## Burlington Planning Commission

## Burlington Planning Commission Special Meeting- Work Session Tuesday, June 21, 2016 – 6:00-9:00 P.M. Burlington Police Department Community Room, One North Ave

### **PROPOSED: ZA-16-14 – Downtown Mixed Use Core Overlay**

*As revised by the Planning staff – June 15, 2016.*

Map 4.2.2-1 *Official Map of the Downtown and Waterfront Core Waterfront Core Official Map*

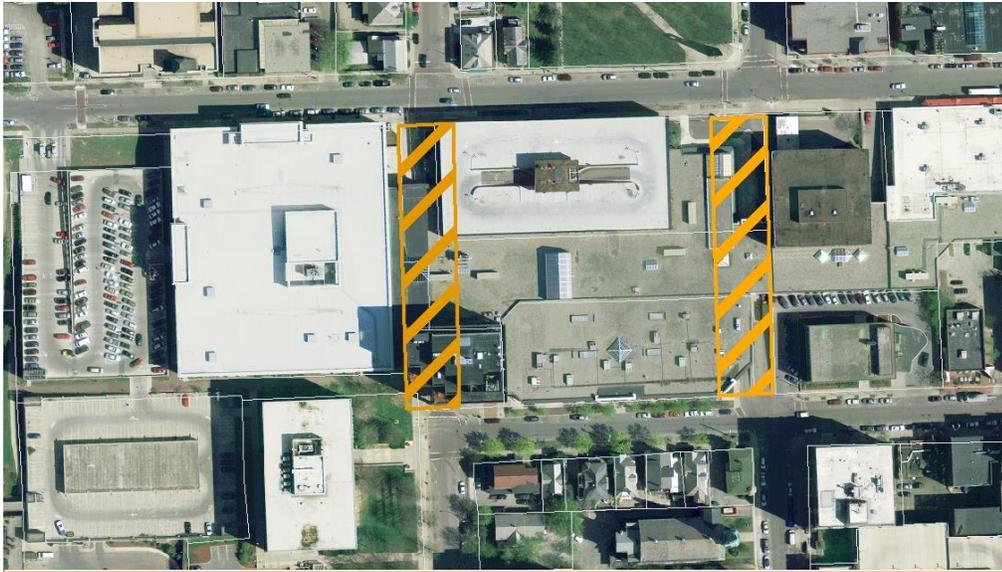
**Comment [DEW1]:** This will ensure that the proposed north-south connectivity on Pine and St. Paul streets envisioned in planBTV is accomplished. The City will have 120-days to initiate proceedings to acquire any land within this area that may be proposed for new development. As proposed, the BTC will comply.

**Comment [DEW2]:** These proposed new ROW's are consistent with the BTC project as proposed

Figure 4.4.1-2 Measuring Height Limits for Church Street Buildings

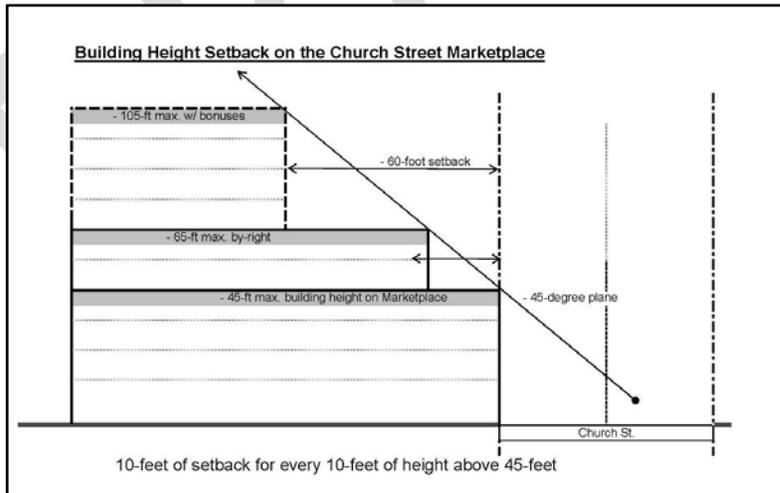
**Comment [DEW3]:** While outside of the proposed new overlay, this change is already envisioned as part of the currently proposed form-based code to provide better compatibility of building heights on Church Street. The BTC project as proposed will need its upper floors to be set back farther in order to comply

*Map 4.5.8-1: Downtown Mixed Use Core Overlay (DMUC) district*

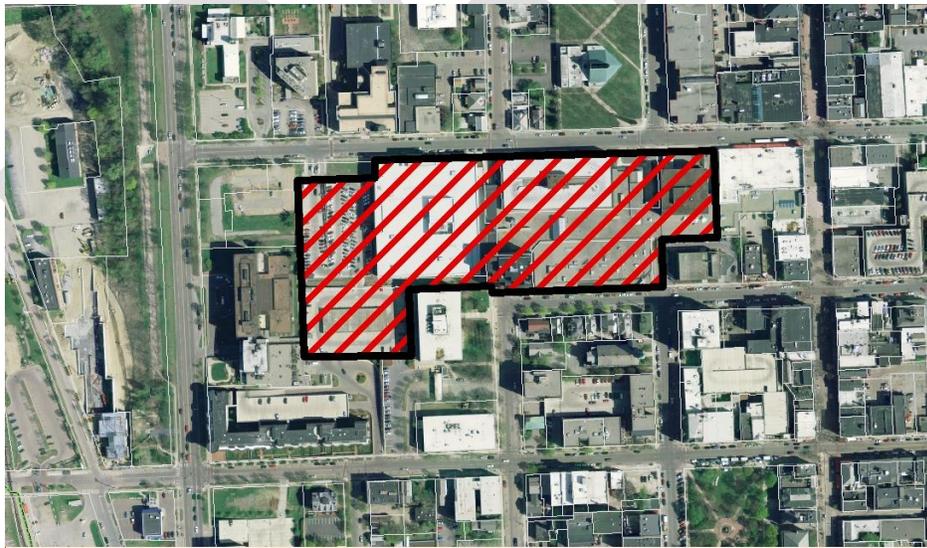
**Comment [DEW4]:** Boundary of this area needs to consider existing and potential development in this area which has generally been supported in planBTV and by the Joint FBC Committee as the part of the downtown where greater height could be appropriate.
